Staff Report

Infill Housing Design Review

File Number: 11-C-26-IH

Location: 3437 Gap Rd. **Parcel ID:** 81 I T 004

SITE PLAN

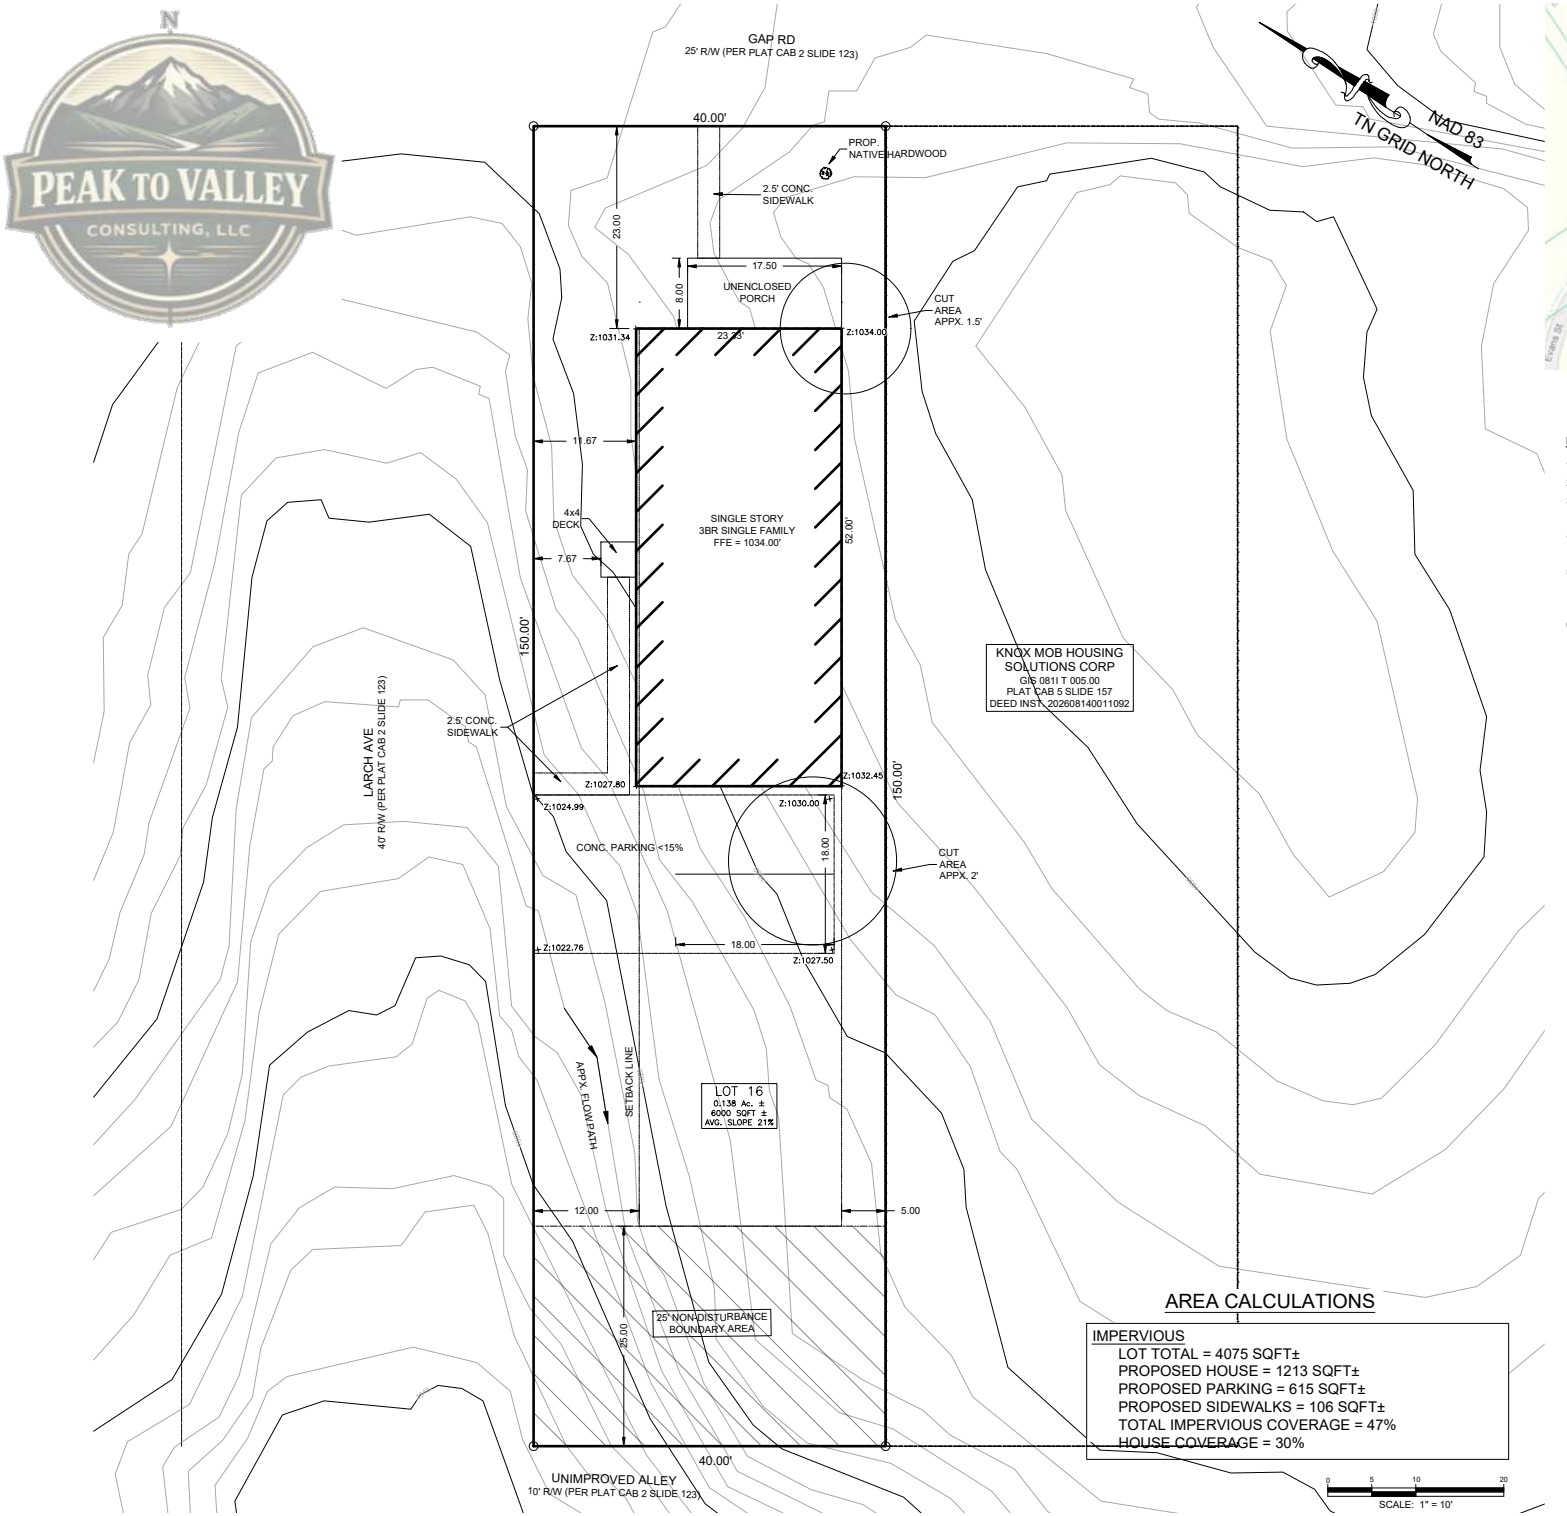
House Orientation and Side Yards: Appropriate. The site plan includes an 11.67’ corner side setback from Larch Avenue, which does not meet the 12’ minimum required by the RN-2 (Single-Family Residential Neighborhood) district. The DRB can approve alternative dimensional standards “in order to realize the principles associated with the guidelines” (Article 16.6.D). The minor reduction to the corner side setback is consistent with others in the area, including the 7’ corner side setback on the block’s other corner lot, and is appropriate for the 40’ wide lot. It does not pose safety concerns to City Engineering.

Alleys, Parking, and Services: Appropriate. The driveway could be revised to provide parking to the adjacent lot that the applicant is also proposing to develop.

Landscape: Appropriate. The tree in the front yard should be an existing tree, as feasible.

LOT 16 – HOUSE A
GAP ROAD DEVELOPMENT

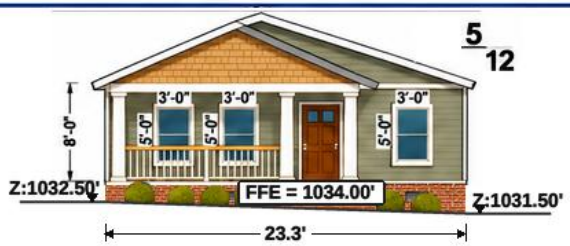
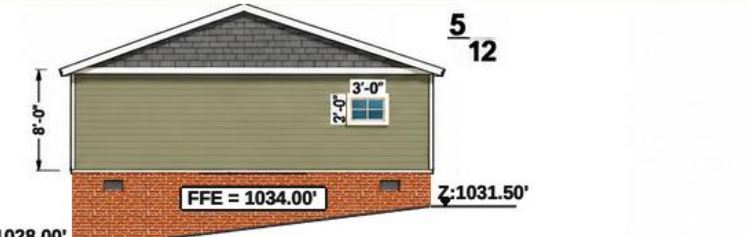
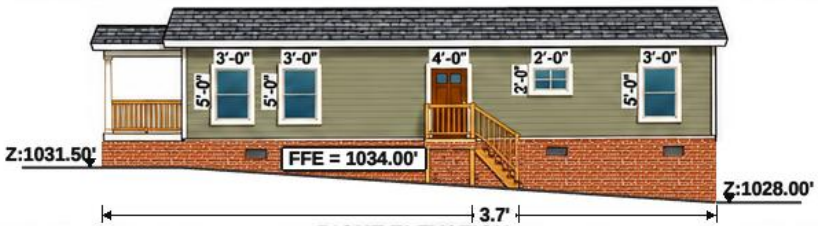
Scale, Mass, and Foundation Height: Appropriate. The house is approximately 10-12’ deeper than the houses on the block, all of which are infill construction built after 2020, with the exception of the only historic house on the block that is 64’ deep. Recent new construction on the other side of Gap Road also exceeds 50’ in depth. The proposed foundation height is appropriate given the slope of the lot, and major changes will require further review by the Board. The brick veneer cladding should be retained.

Porches and Stoops: Appropriate. The porch will be built on site. The header beam, handrailing details, and turned columns should be retained, and the columns should be at least 6” by 6”. The porch width and placement differentiates it from the adjacent new construction.

Windows and Doors: Appropriate. All 3’ by 5’ windows should be single-hung or double-hung.

Roof Shapes and Materials: The 5/12 pitch does not meet the 6/12 minimum typically approved within the overlay, and it cannot be increased for this multi-sectional plan. The Board has approved a multi-sectional house with a 5/12 pitch roof within the overlay that featured a similar front gable design with a site-built front porch (3-A-22-IH, 1506 Ohio Ave). Given the lack of context and additional design elements that align with guideline recommendations, the 5/12 pitch can be appropriate, as long as the trim at the base of the gable fields, accent siding, and porch details are retained. The Board should discuss whether other interventions are necessary.

Siding Materials: Appropriate. The accent siding and siding colors differentiate the house from the adjacent new construction and should be retained.
